DP12-006 FORD 12/14/2012 Appendix D - Litigation Prevention Files

Last action taken (as of 10/16/2009 3:37:07 PM GMT):	Send for engineering input
Comment:	Please review for the 10-21-09 meeting.
Author:	JISAACSO
Tracking Number:	087-2009-1872
Author Tracking Number:	087-2009-5432
Title:	2009-2010 ESCAPE/MARINER/& HYBRID
	ELECTRIC VEHICLES, AND 2010
	FUSION/MILAN/& HYBRID ELECTRIC
	VEHICLES - DIAGNOSTIC TROUBLE CODES
	P0121, P0122, P0221, P0222, P2135.
Article Type:	TSB

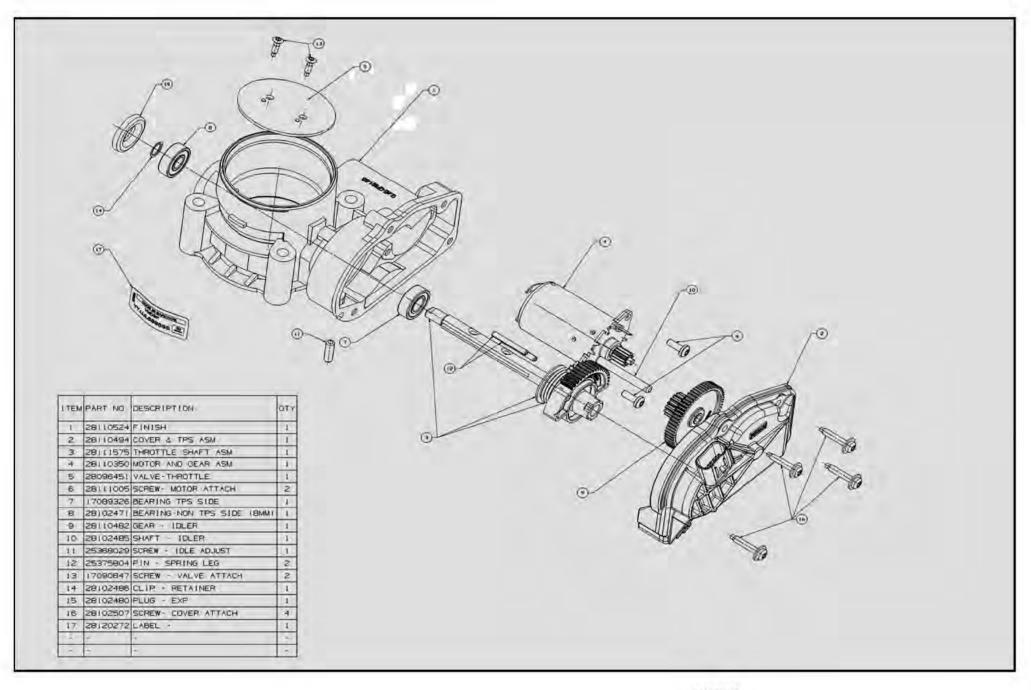
Attached is an exploded view of the ETB that you use for the 2.5. I have another presentation that has a lot of information in it and some of it is out of date. I'm going to take some of the relevant slides out of that and forward to you.
